BULLETIN NUMBER:
IB23-J-001B

REPLACEMENT LONG BLOCKS & INSTALLATION TIPS

- 2012 - 2020MY Isuzu N-Series Vehicles
Equipped with 6.0L Gasoline or RPO KL8 Alternative Fuel Capable Engines
- 2022MY Isuzu N-Series Vehicles
Equipped with 6.0L Gasoline Engines

Figure 5. KL8/LC8

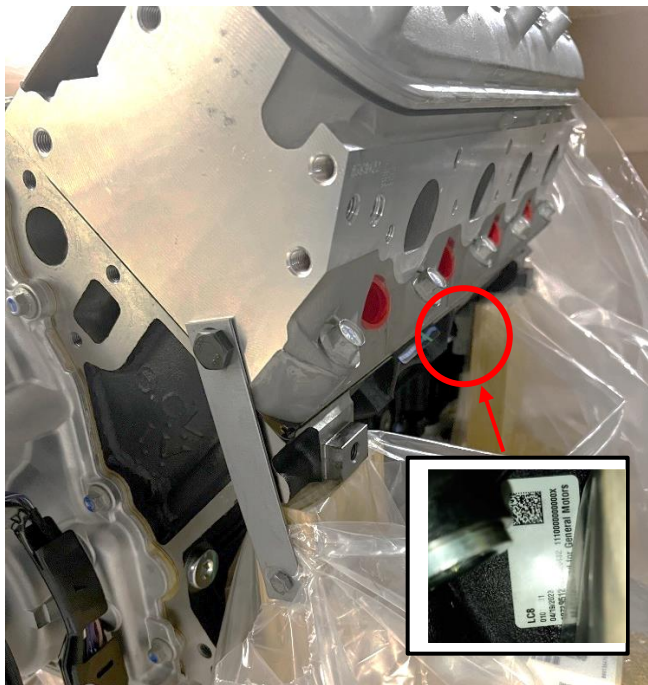
Refer to Figures 5 and 6 for the locations of the replacement Engine Serial Numbers (ESN) on 6.0L KL8/LC8 engines.

Note: for replacement KL8 engines, the ESN can be found on labels on the oil pan and on the cylinder head and also on a label on the packaging material for the new engine.
